Submissions Report

WOLLAR SOLAR FARM

Wollar Solar Farm Submissions Report

Table 6-1 Public authority submissions and proponent's response

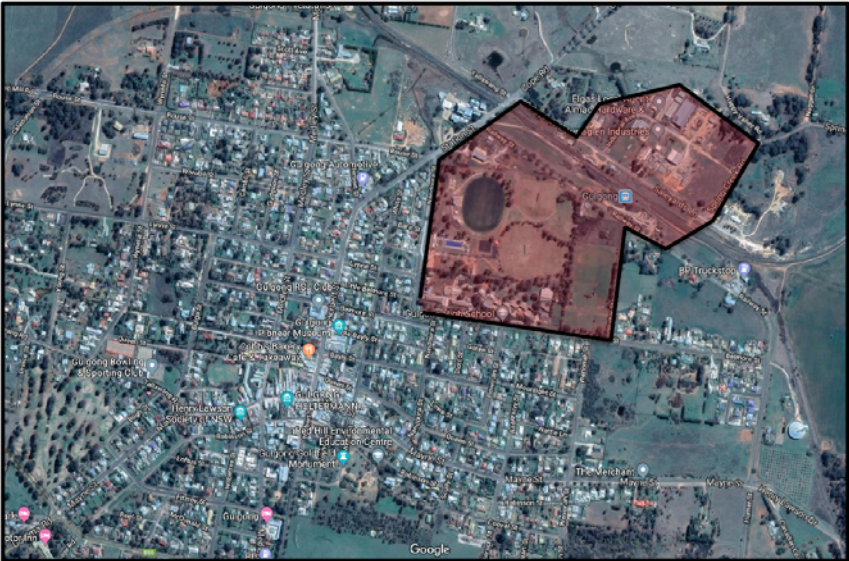
Traffic volumes	Conflicting numbers relating to bus trips in section 3.3.1 and 4.1.1.	The Addendum TIA (Amber, 2019) builds on the updated TIA provided by Ontoit (2019) and provides a revised assessment of shuttle bus distribution across the road network that is summarised below and provided in Appendix C. It is noted that staff will be located predominantly within Mudgee and Gulgong. Shuttle buses will transport approximately 80% of construction staff to the site (up to 256 people during peak construction, from months 6 to 14). A monthly breakdown of the anticipated number of construction staff is provided in the table below.
	Further information required relating to transportation of staff on buses and pick up/drop off locations.

Shuttle buses travelling to/from Mudgee are anticipated to utilise Wollar Road, and shuttle buses travelling to/from Gulgong are anticipated to utilise Ulan-Wollar Road to limit the number of vehicle movements along Wollar Road. For the purposes of the assessment it has been assumed that 70% of staff (224 people) will be based in Mudgee and 30% (96 people) will be based in Gulgong. Based on this assumption, shuttle bus distribution would be comprised of up to

Issue	Detail of issue	Proponent Response
		<p>28 movements per day (and up to 14 movements during peak hour) on Wollar Road and up to 12 movements per day (and up to 6 movements during peak hour) on Ulan – Wollar Road.</p> <p>The remaining staff will access the site using private vehicles. Assuming a vehicle occupancy of 2 for workers, the proposal is expected to generate up to 30 light vehicle movements during each the peak construction period.</p> <p>The construction phase is estimated to take 12-18 months and it is proposed to prepare a Workforce Travel Plan to support the number of workers who will be targeted to travel by bus. The travel plan would document a number of elements including (but not limited to):</p> <ul style="list-style-type: none"> • Bus routes. • Bus pick up and drop off locations. • Bus movement frequencies. • All day parking options. <p>The Workforce Travel Plan would be incorporated within the CTMP and would be monitored and revised if targets are not being met.</p> <p>Ontoit (2019) has provided some preliminary options in relation to bus routes, pick up / drop off locations and parking options from the regional centres of Mudgee and Gulgong. These options, which do not require any constructed infrastructure, do not form part of the proposal but are provided to demonstrate the feasibility of providing pick up / drop off locations and parking near to the regional centres.</p> <p>For workers originating in Gulgong, consideration would be given to including an all-day parking facility in the north-east of the town within the area highlighted in red in the figure below.</p>
